July 14, 2015

Re: Arizona Regional Haze Plan Revision for Cholla Power Plant

On behalf of National Parks Conservation Association and Sierra Club (collectively, the “Conservation Organizations”), Earthjustice respectfully submits the following comments regarding the Arizona Department of Environmental Quality’s (ADEQ) proposed Best Available Retrofit Technology (BART) “reassessment” for the Cholla Power Plant.

Figure 3 Cumulative NOx Emissions Associated with EPA's FIP vs. Cholla BART Reassessment over 2016-2046

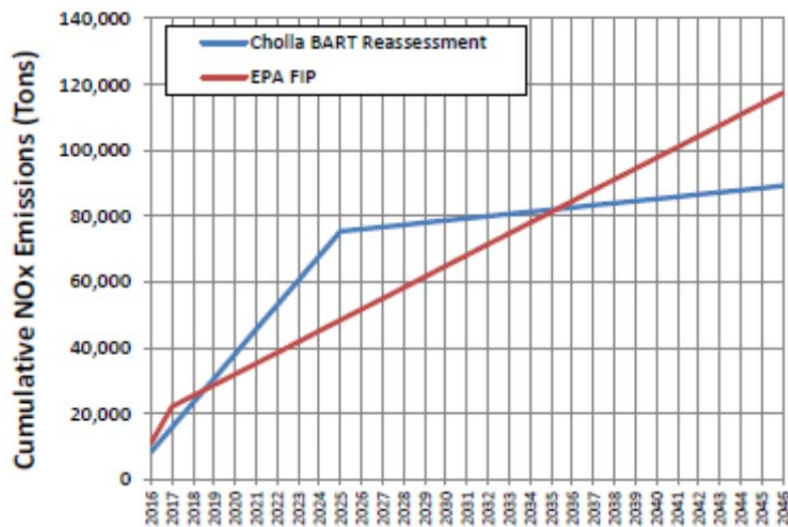
First, the record shows the Cholla BART “reassessment” would increase Cholla’s NOx pollution compared to the existing BART determination.¹⁴ Under the BART “reassessment,” between 2018 and 2025, Cholla would emit *4,161 tons per year more NOx pollution* than it would under the existing BART determination.¹⁵ In addition, the BART “reassessment” would result in greater cumulative NOx pollution for eighteen years after the BART compliance deadline.¹⁶ Figure 3 from ADEQ’s proposal illustrates how the BART “reassessment” would increase Cholla’s NOx pollution by allowing Units 3 and 4 to continue operating for the next ten years without installing additional pollution controls.¹⁷

As the Ninth Circuit recently stated, it would not be “difficult[.]” to show a section 110(l) violation if an existing implementation plan unambiguously required a certain level of pollution reductions, and a plan revision would result in more pollution. *El Comite Para el Bienestar de Earlimart*, 786 F.3d at 696 (“The difficulty with [the] argument” that a revision weakened an existing plan’s 20% pollution reduction requirement, is that the existing plan “is ambiguous, because it refers to both a 12% reduction and a 20% reduction.”). But this is exactly what would occur under the BART “reassessment,” as Arizona’s new BART determination would result in an additional 4,161 tpy of NOx pollution for more than seven years after the BART compliance deadline. Moreover, when Cholla’s cumulative NOx emissions are considered, the BART “reassessment” would result in increased pollution levels until 2035, which is nearly two decades after the BART deadline.

Figure 6 Comparison of Integrated Visibility Impacts at Petrified Forest National Park Associated with EPA FIP vs. Cholla BART Reassessment

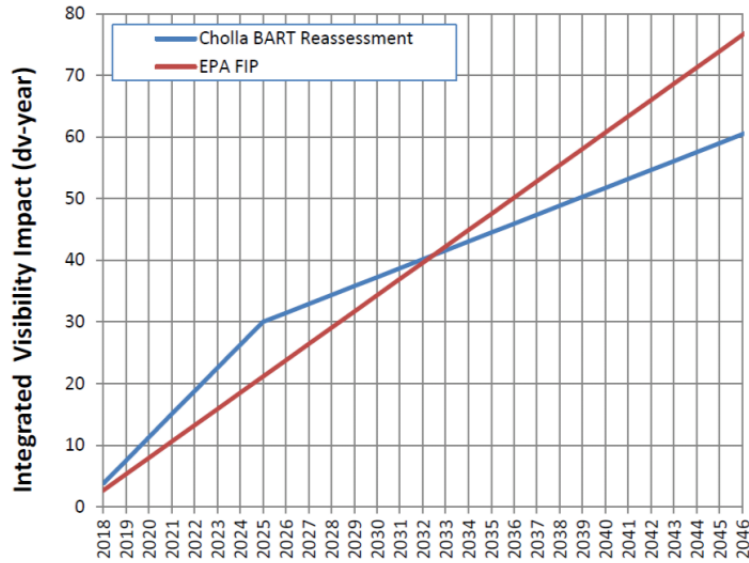
Second, the record also shows the BART “reassessment” would worsen air quality because it would result in worse visibility conditions than the existing BART determination. The existing BART determination will provide significant visibility benefits beginning immediately after the December 2017 compliance deadline. But for several years after that compliance deadline, the BART “reassessment” would result in worse visibility conditions at Class I areas compared to the existing BART determination.¹⁸ For example, Cholla’s air pollution causes the greatest visibility impairment at Petrified Forest National Park, which is the closest Class I area. As Figure 6 to ADEQ’s proposal shows, Cholla’s visibility impacts at Petrified Forest would be worse under the BART “reassessment” for fifteen years after the BART compliance deadline.¹⁹

Figure E-2: Plot of Predicted Cumulative Visibility Impacts at Grand Canyon National Park Associated with EPA FIP (red) vs. Proposed BART Reassessment (blue)

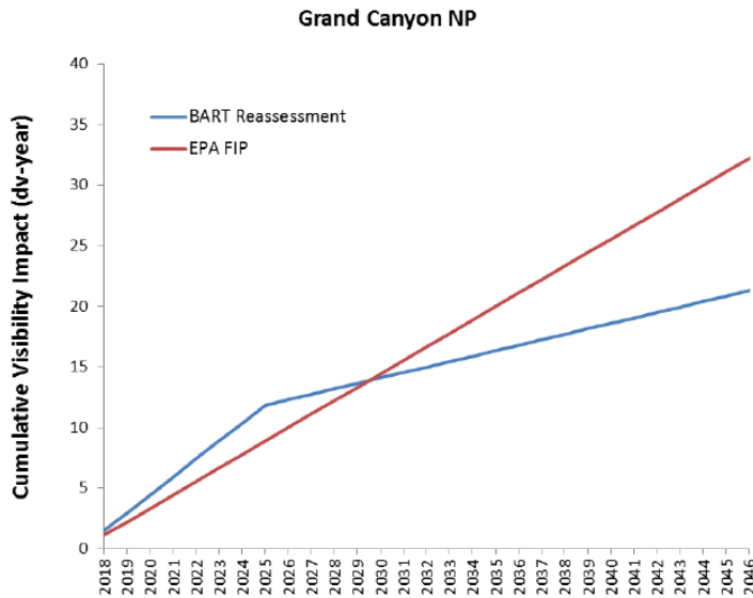
The situation is similar at the Grand Canyon. As Figure E-2 to ADEQ’s proposal shows, Cholla’s visibility impacts at the Grand Canyon would be worse under the BART “reassessment” for twelve years after the BART compliance deadline.²⁰ Furthermore, ADEQ acknowledges that this same “general pattern” of worse visibility impacts under the reassessment holds true at the other Class I areas impacted by Cholla’s air pollution.²¹
